# Structural Design Associates, Inc.

September 20, 2011

Re: Property at 2073 Ford Parkway, St. Paul, Minnesota

B) 12" BASEMENT BLOCK WALL PLAN DETAIL

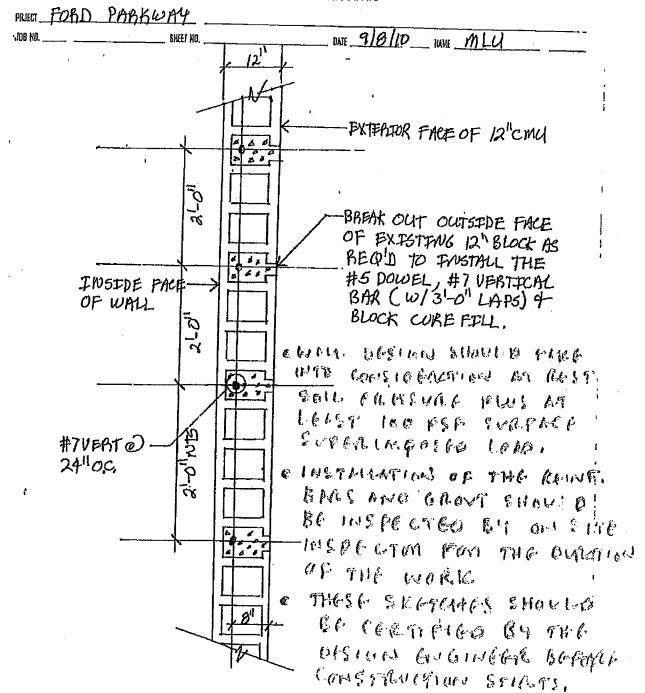
THIS CHINE CTIAN : "LEDS. TO BE CHECKED FOR
